PROPERTY ADDRESS:
2501 N 55TH ST, UNIT 1
TAMPA, FL 33619
(FOLIO NO. 160209-0002)

Site - Ryan Taylor - Approved with Comments
Natural Resources - Michael Lousias - Approved with Comments
Building - Chuck Quade - Approved - 3/30/2025

NEW TOWNHOMES
2501 NORTH 55th STREET UNIT 1
TAMPA, FL 33619

SITE PLAN
Scale: 1"=10'

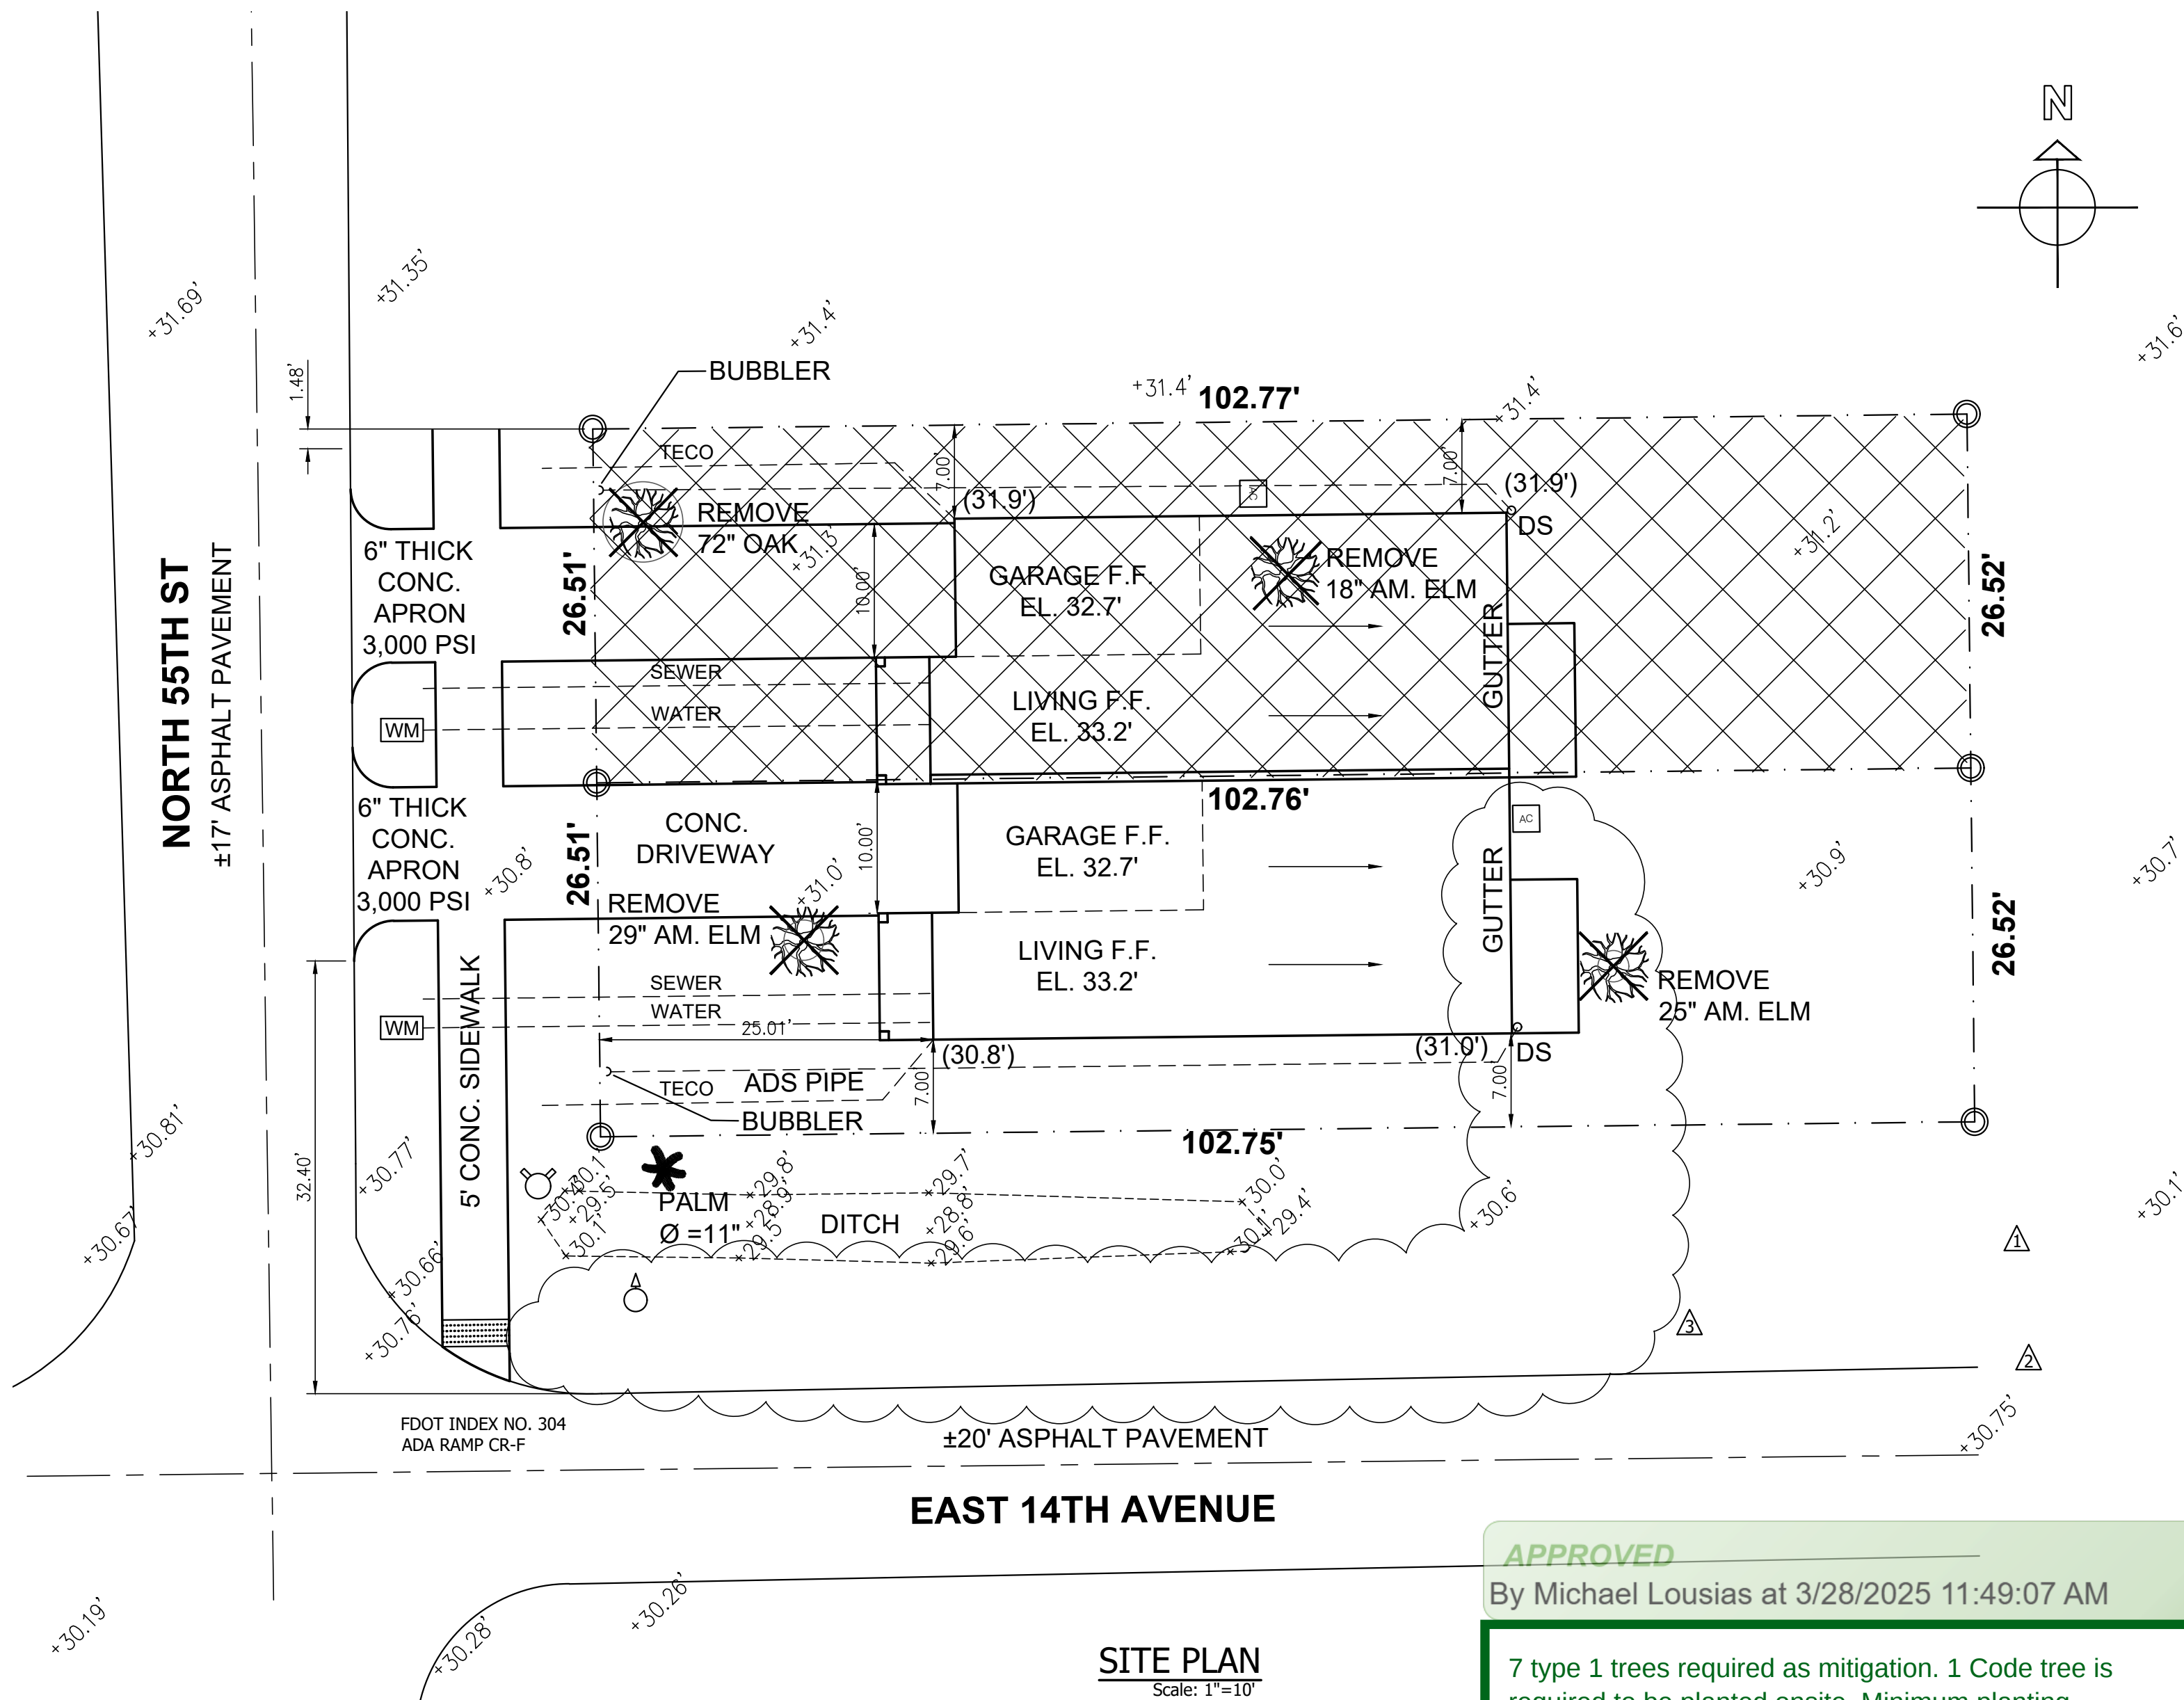
Driveway Approved per
DET-24-0000109

7 type 1 trees required as mitigation. 1 Code tree is required to be planted onsite. Minimum planting standards; 2.5" caliper, 8-10' tall and 5-6' spread.

Sidewalk In-Lieu Application
due before C/O issue.

SITE PLAN
Scale: 1" = 10'

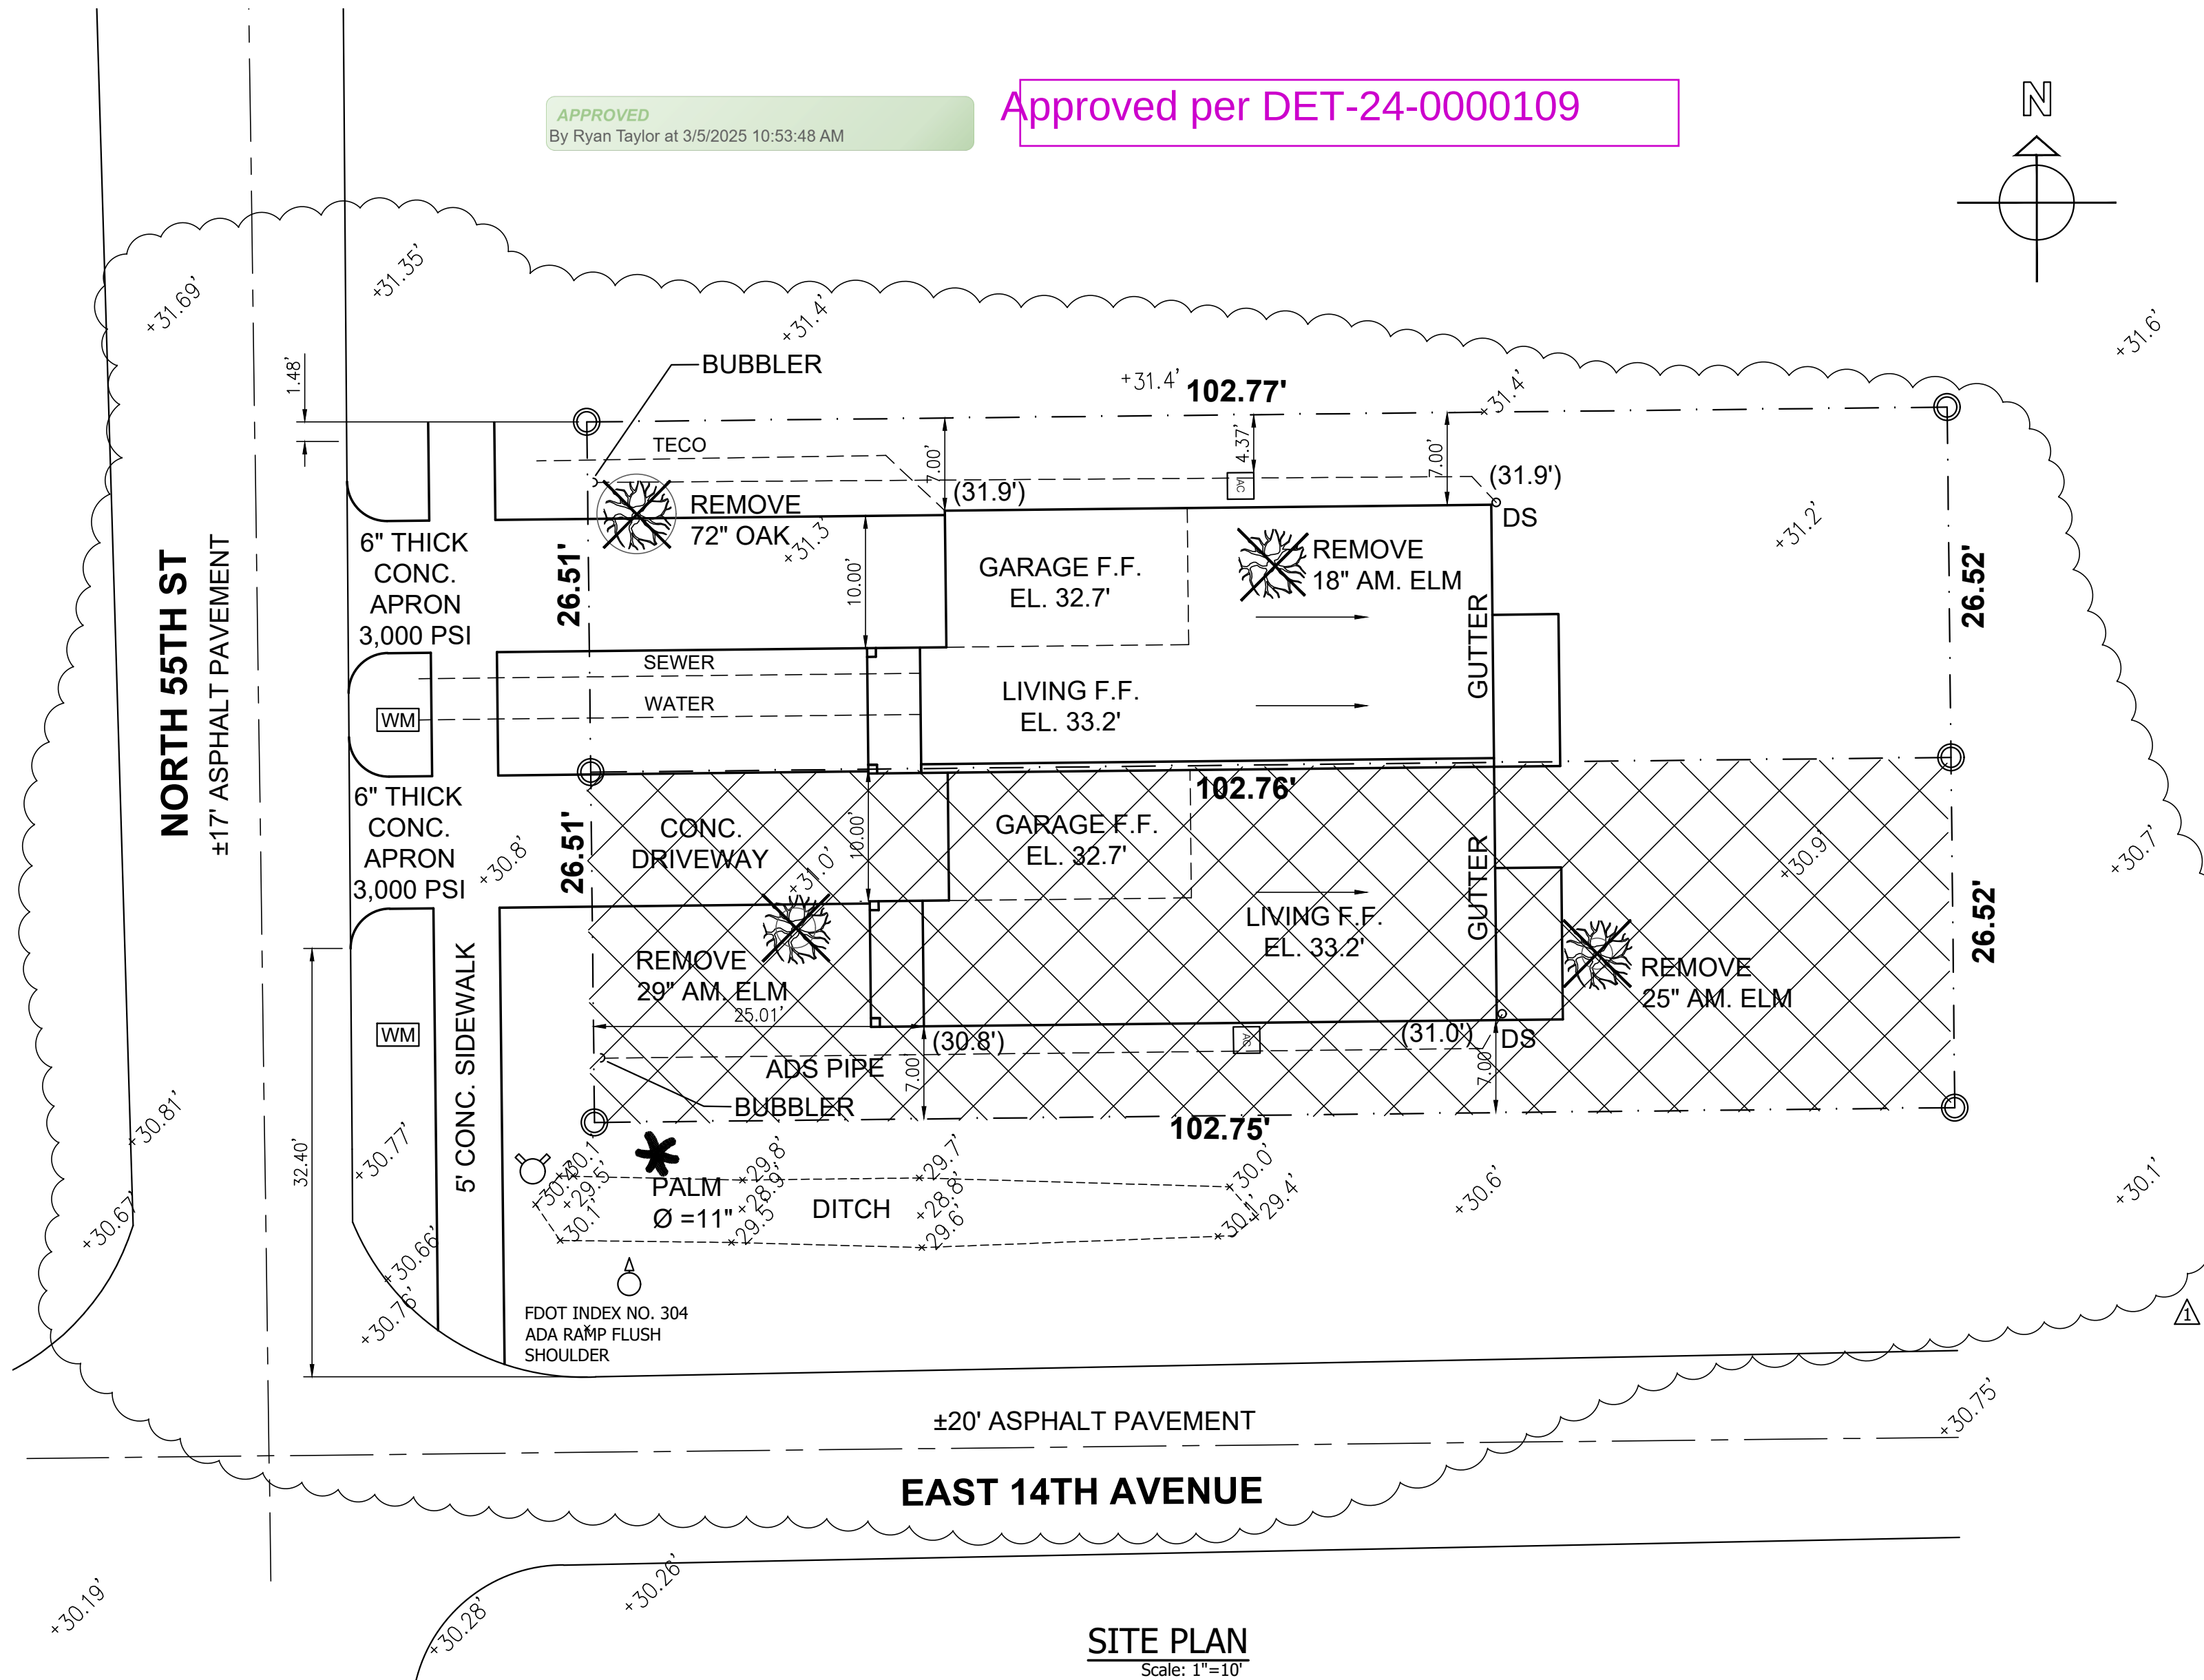
7 type 1 trees are required as mitigation. 2 Code tree is required to be planted onsite. Minimum planting standards; 25" caliper, 8-10' tall and 5-6' spread.

Approved per DET-24-0000109
